GROUND WATER RECHARGE

PHOENIX URBAN STUDY

FEBRUARY 1977

COMMENTS ON "GROUND WATER RECHARGE PHOENIX URBAN STUDY February 1977"

GROUND WATER RECHARGE
 PHOENIX URBAN STUDY
**SALT RIVER INFILTRATION
 BASIN— PLAN 3**
 U S ARMY ENGINEER DISTRICT
 LOS ANGELES, CORPS OF ENGINEERS
 TO ACCOMPANY REPORT DATED:

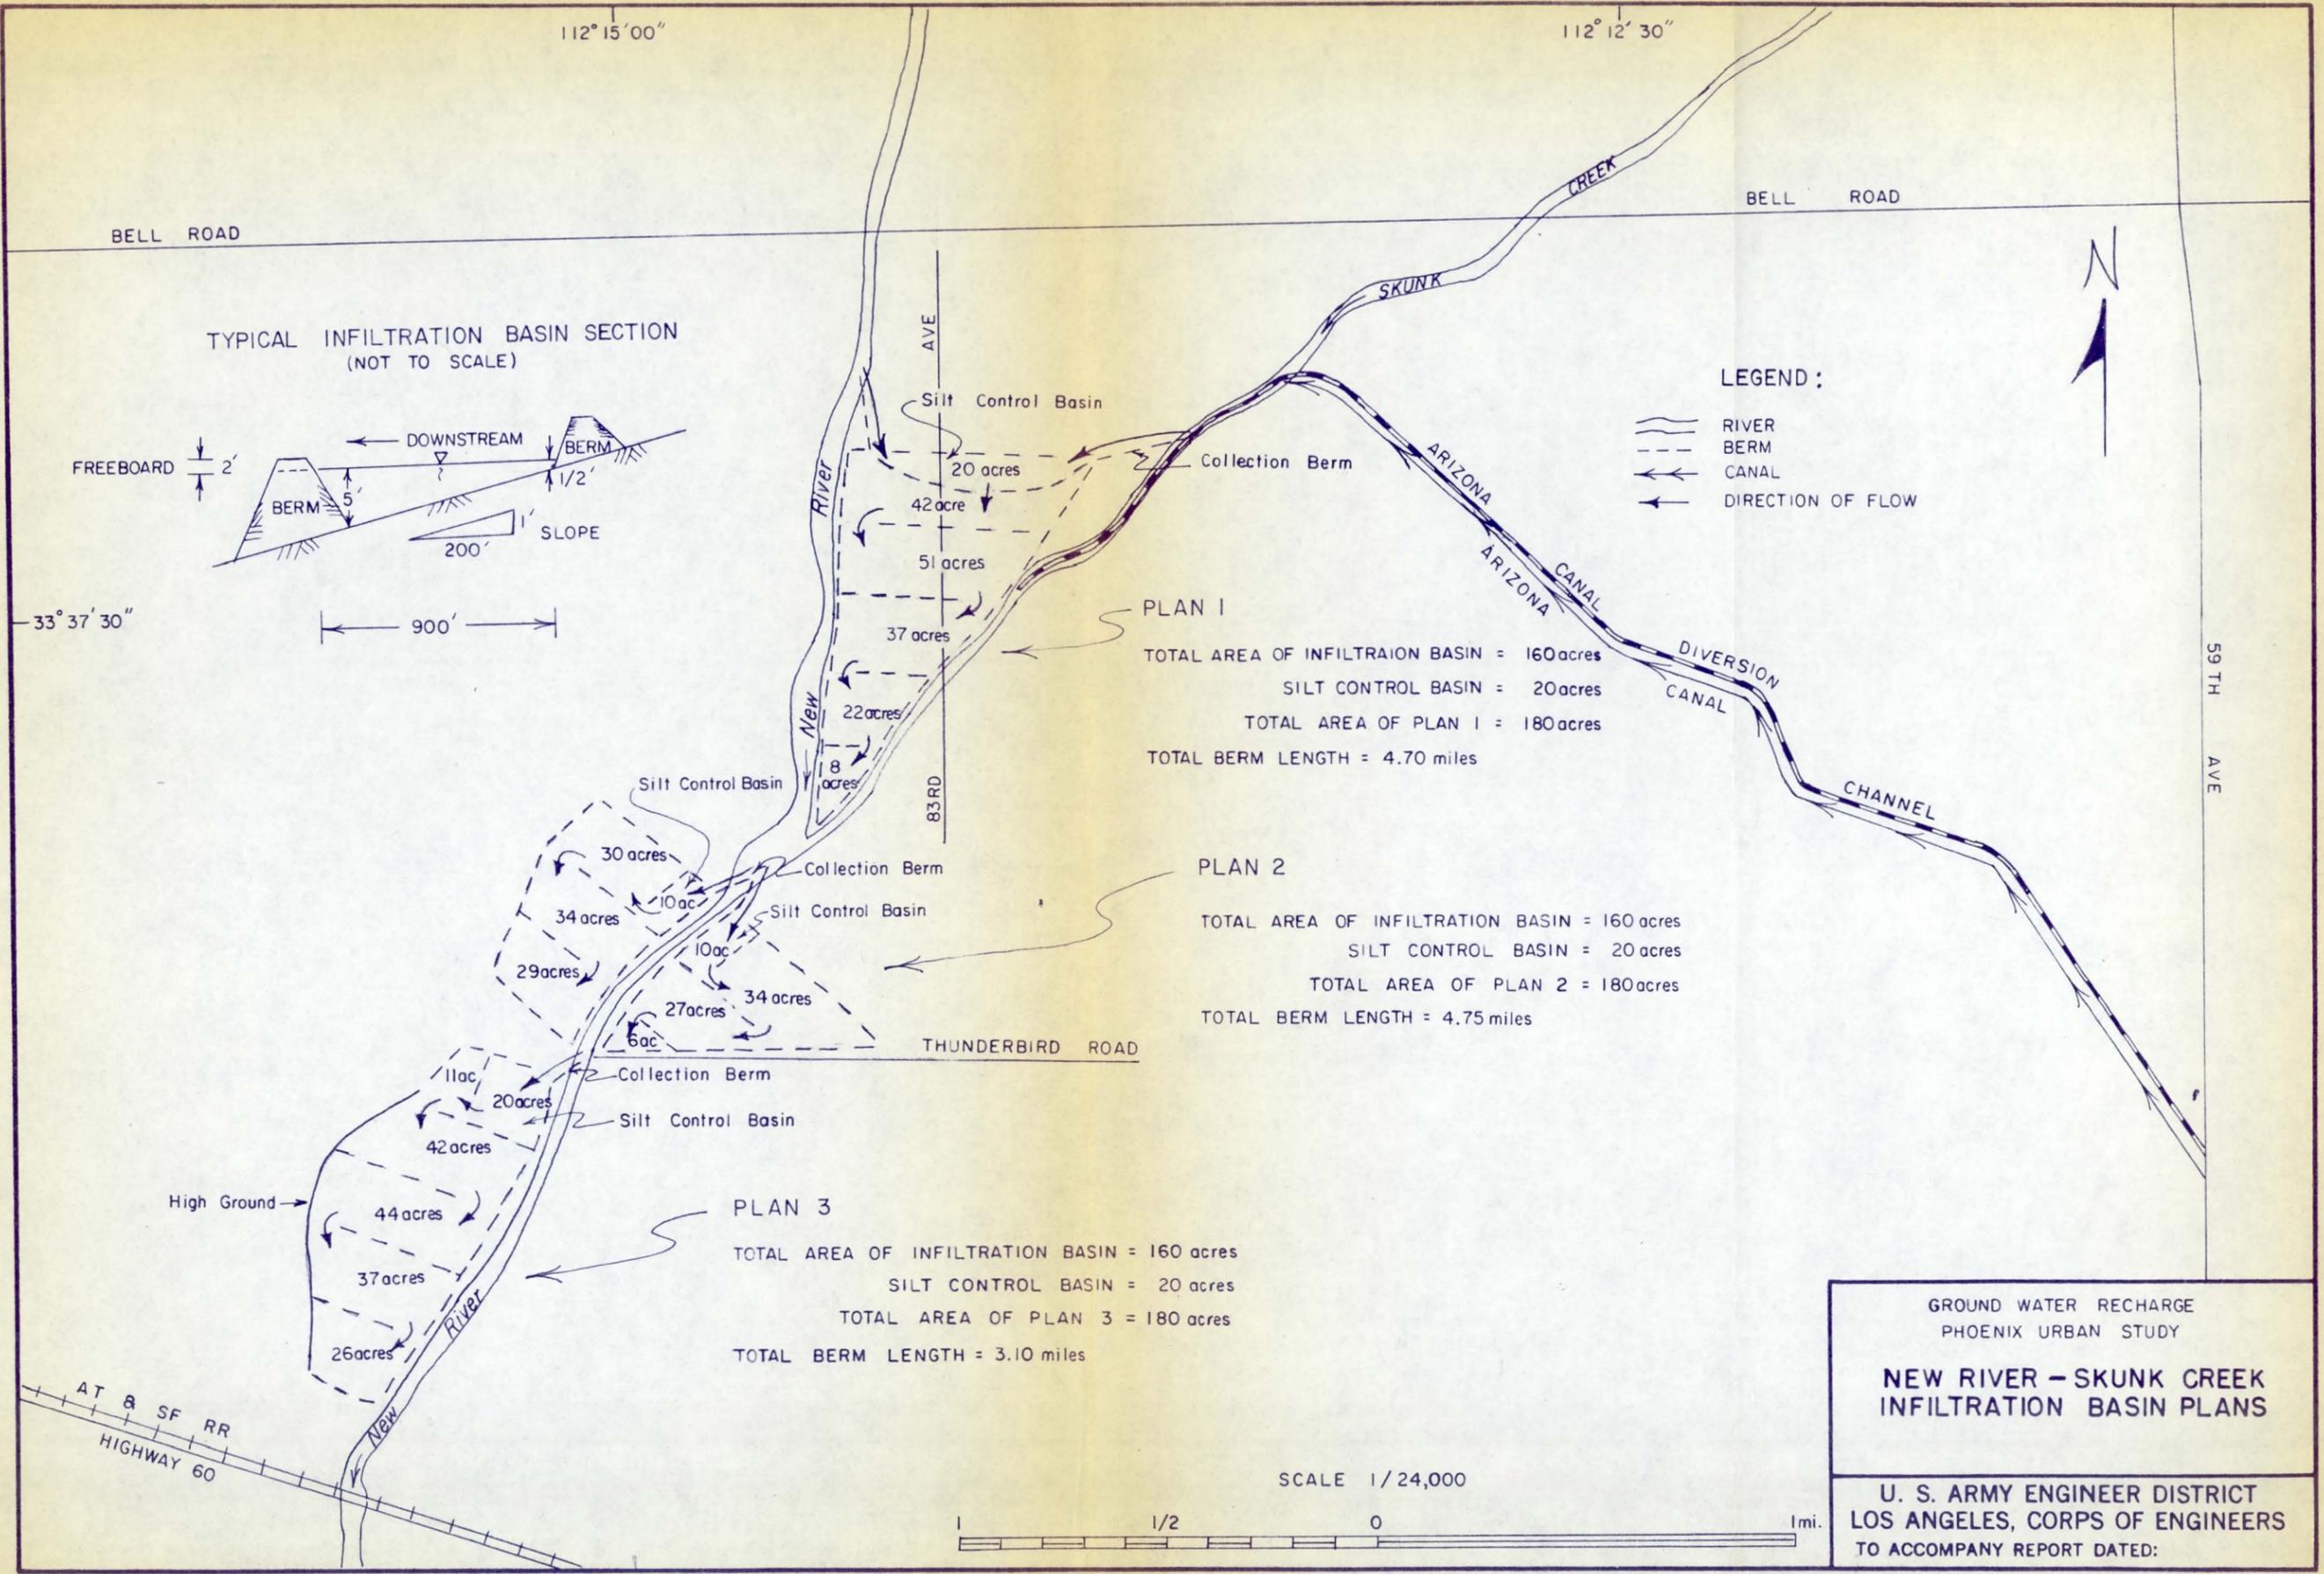
A cursory examination of aerial photographs taken in 1976 and 1977 indicates that there are about 1,000 acres of excavated areas in the Salt River between the Baseline Highway and 35th Avenue. This compares favorably with the Corps estimated area requirement for recharge of 2,000 cfs or 850,000 acre feet/year to allow joint use storage in the Orme Dam flood control pool (paragraph 3.04). That is, it compares with the abilities of the systems shown in Plates 3, 4 and 5.

It should be noted that part of the recharge areas shown on Plates 3, 4 and 5 are located on the Salt River Indian Reservation. While realizing that this is a technical report, I think that consideration should be given to consultation with the Tribal Council, along with other legal considerations discussed in Paragraph 1.04c.
